Complaint: Insects in the Tail Light - Replacing and Reworking Tail Lights if Necessary (142/21)

Model Line: **Macan (95B)**

Model Year: **As of 2019**

Concerns: **Side tail lights (left and right)**

Insects getting into tail light

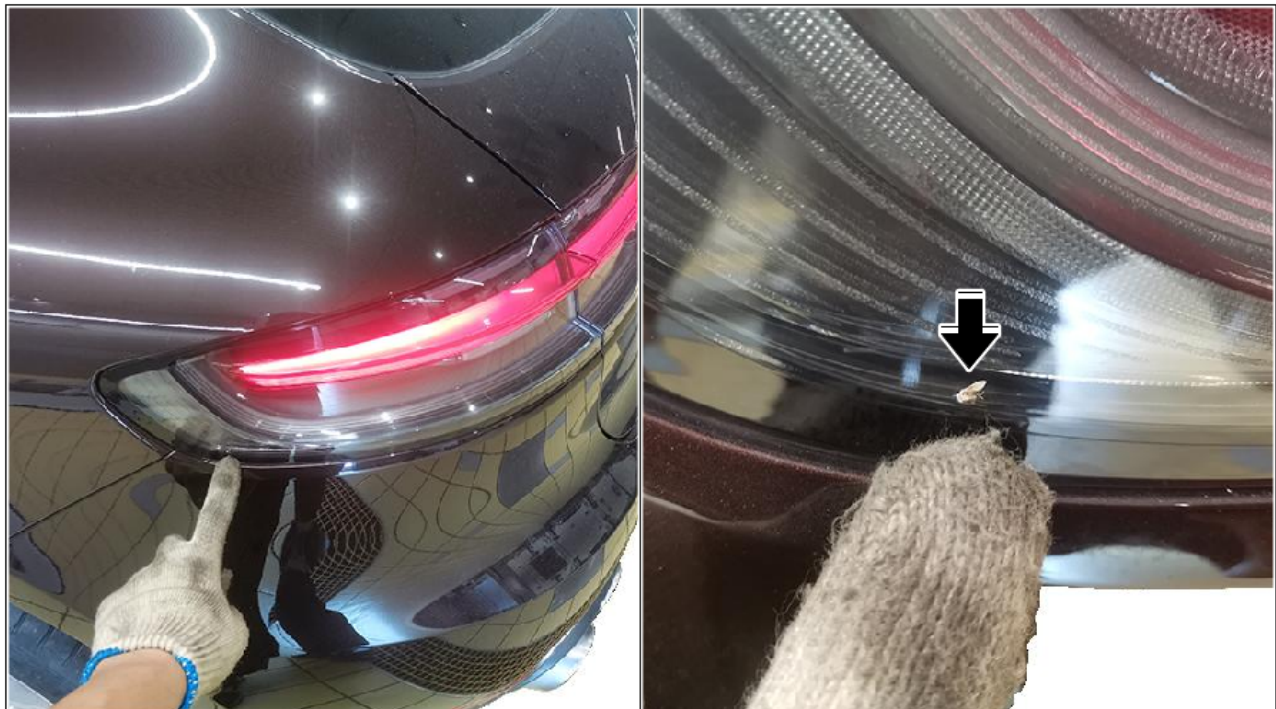
Information: The fact that the side tail lights open inwards for condensation reasons means that insects can get inside the tail light through certain openings in the body and tail light.

Action required: In the event of a customer complaint, replace the affected tail light and close off the opening for the cable bushing using a plastic foam strip.

Retrofitting plastic foam strip

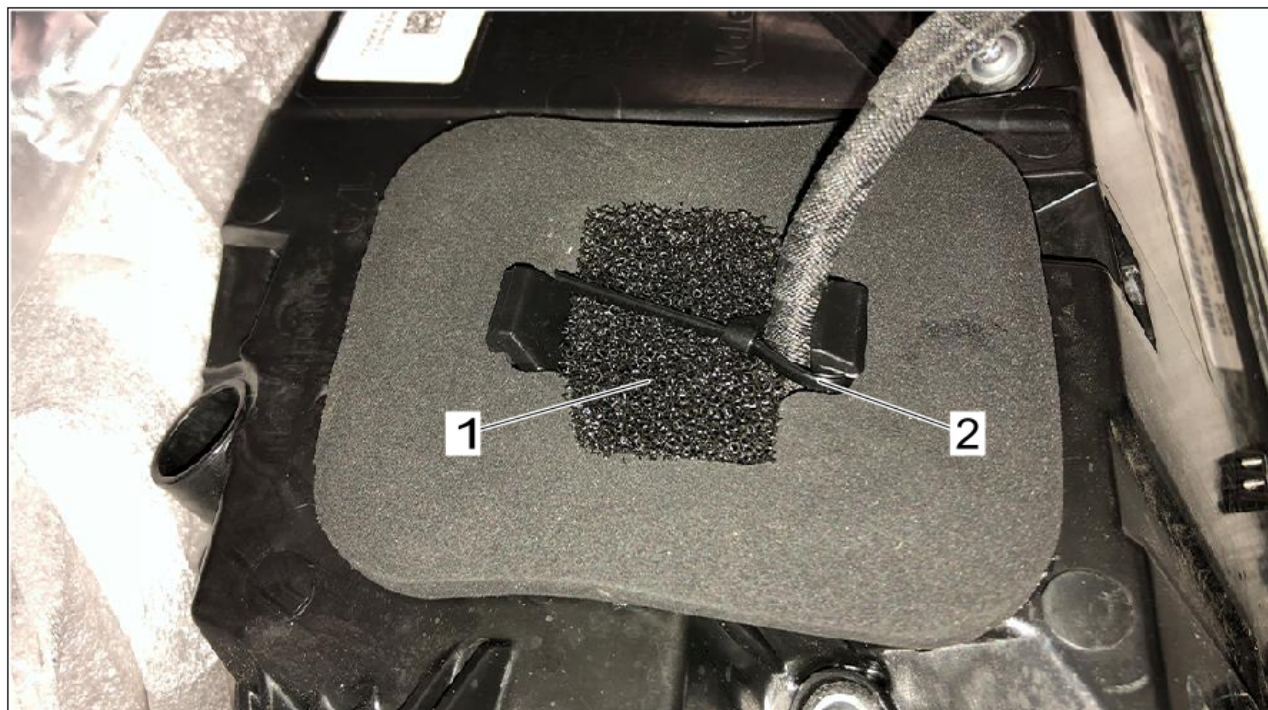
If insects are not getting into both tail lights, only retrofit the plastic foam strip on the tail light that is not affected.

- 2 Before installing the tail light, affix a plastic foam strip ⇒ *Retrofitting plastic foam strip -1-* at the opening of the cable bushing as shown in figure ⇒ *Retrofitting plastic foam strip*.
- 3 Route electric line for the tail light as shown in figure ⇒ *Retrofitting plastic foam strip* and secure it at the edge with a tie-wrap ⇒ *Retrofitting plastic foam strip -2-*. Cut off the extra length at the end of the tie-wrap using side cutters.
- 4 Install tail lights. ⇒ *Workshop Manual '943119 Removing and installing tail light'*
